TM 11-6625-274-35

TEST SETS, ELECTRON TUBE TV-7/U,
TV-7A/U, TV-7B/U, AND TV-7D/U

CHANGE }
No. 5 }

**Direct Support, General Support, and Depot Maintenance Manual
TEST SETS, ELECTRON TUBE TV-7/U,
TV-7A/U, TV-7B/U, AND TV-7D/U**

Figure 44(2). Test Set, Electron Tube TV-7D, schematic diagram (sheet 2).

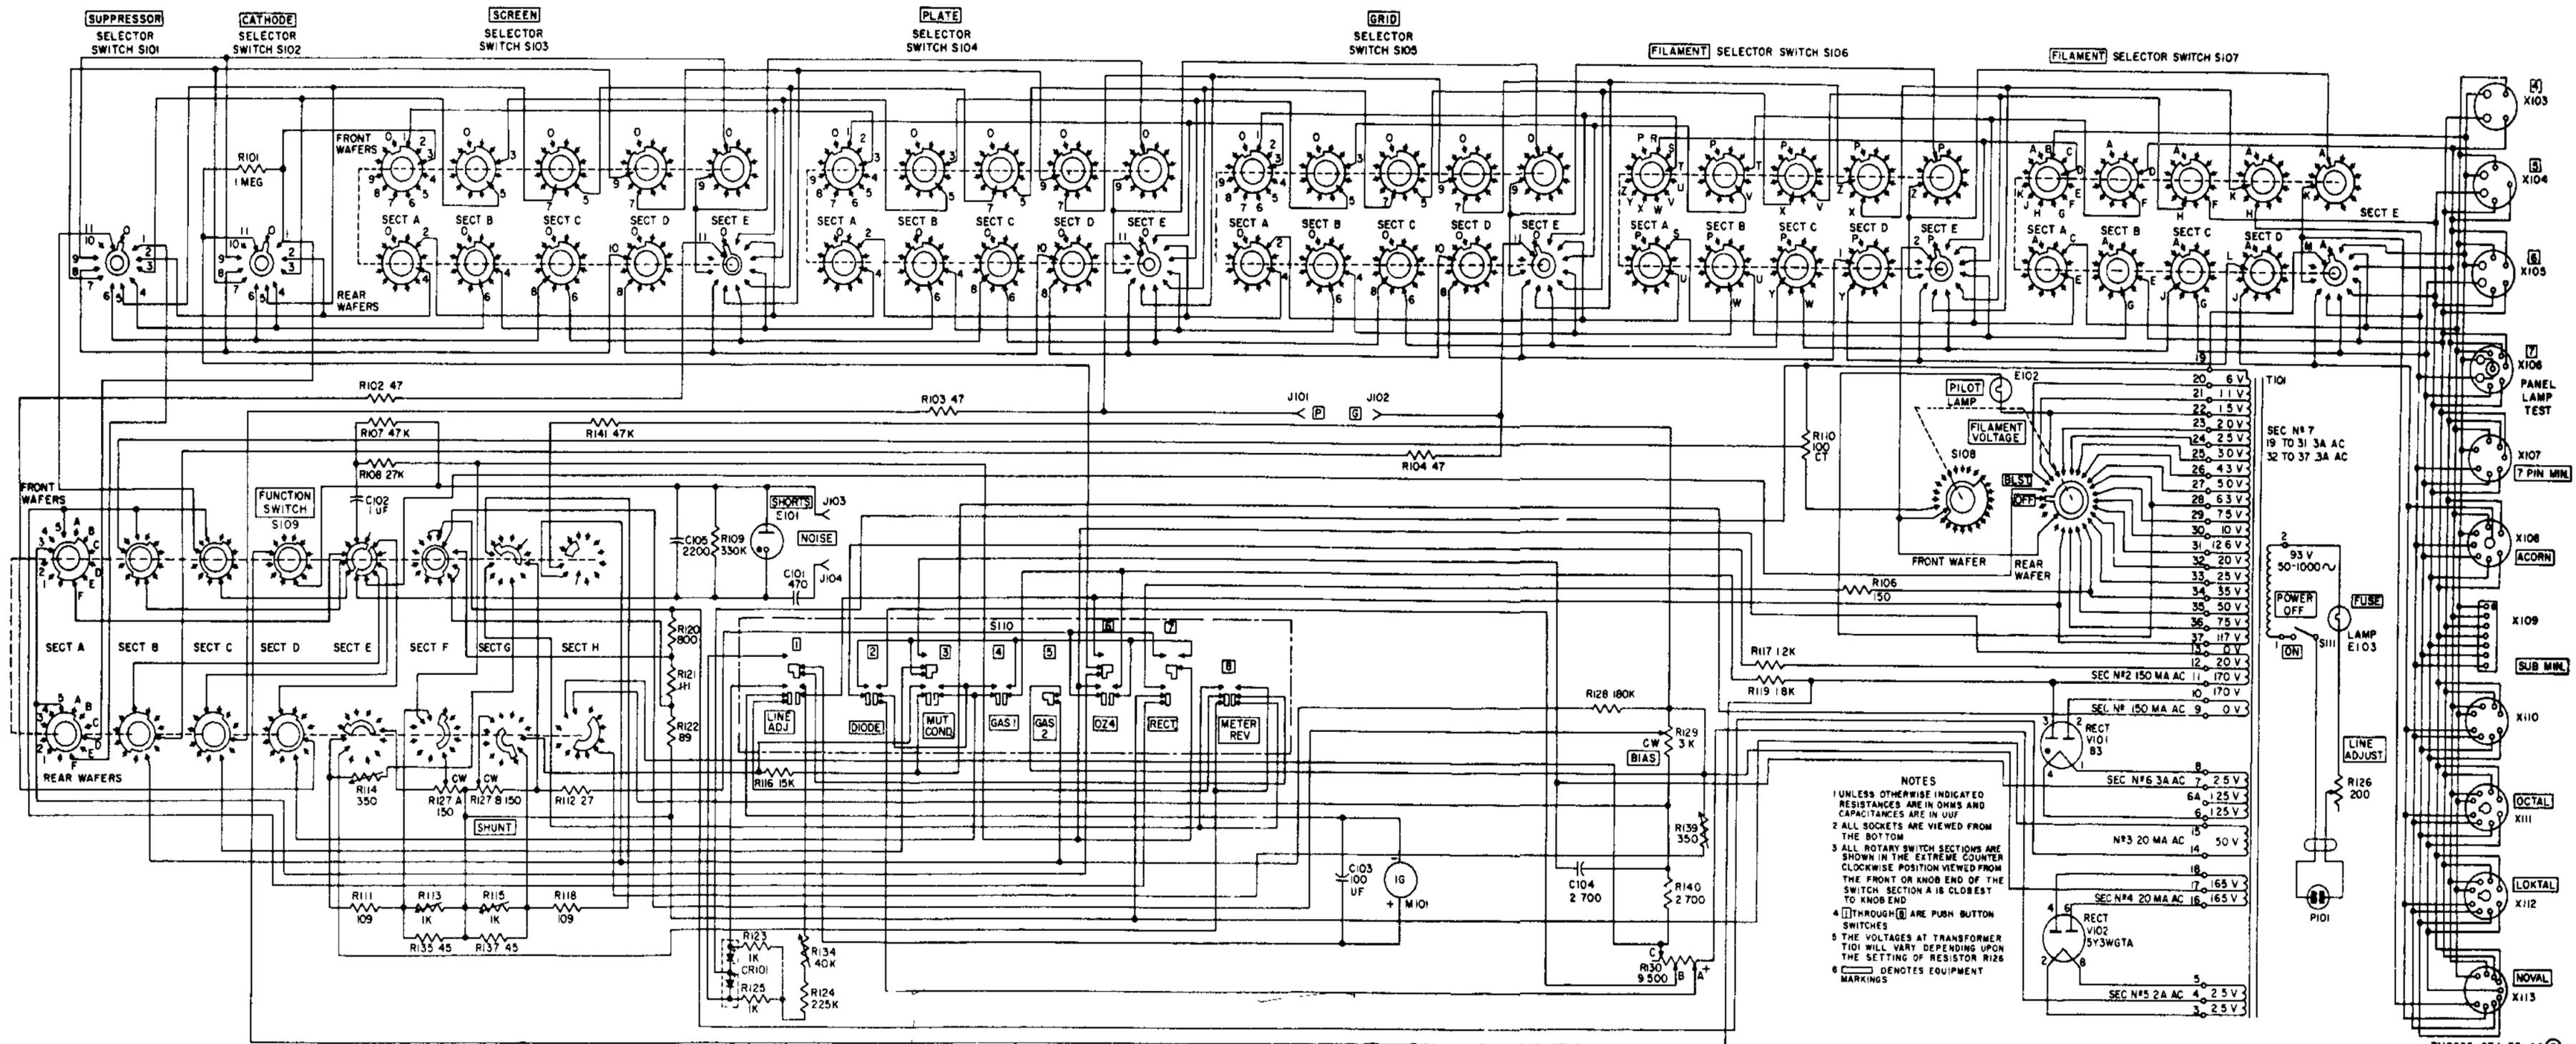
Figure 44② (sheet 2), switch S109, section F. Delete the connection between contacts D and E and substitute 2 connections between C and E.
